# Access Compliance Report

## Public Rights-of-Way

| Intersection ID: 44786                  | Main Street: AYRSLEY_TOWN_BV | Cross Street: KINGS_PARADE_BV           | Location: SE           |
| ADA ID: 1514ABEA8350                    | Ramp Type: Perp              | Initial Pass/Fail: Fail                 | Overall Compliance: No |

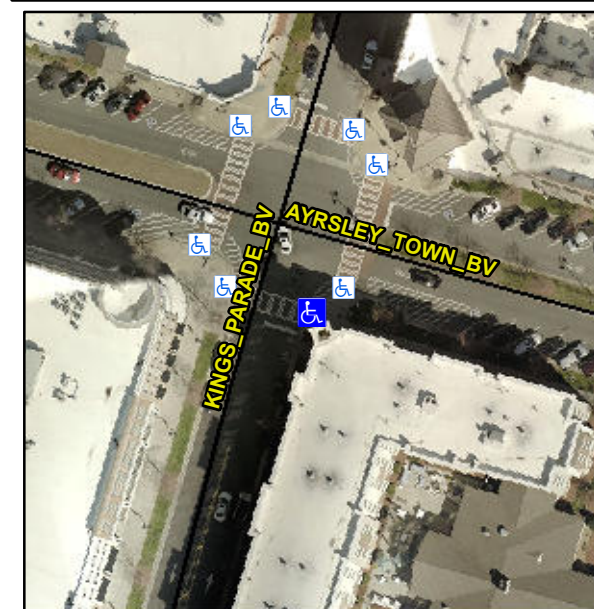
**Not Found, R304.2.2, R304.5.3**

| Compliance | Description           | Data  | Compliance | Description                 | Data |
|------------|-----------------------|-------|------------|-----------------------------|------|
| N/A        | Ramp Length (in)      | 91.0  | No         | Ramp Slope (%)              | 9.2  |
| Yes        | Ramp Width (in)       | 48.0  | No         | Ramp XSlope (%)             | 3.2  |

**Remove & Replace Entire Ramp.**
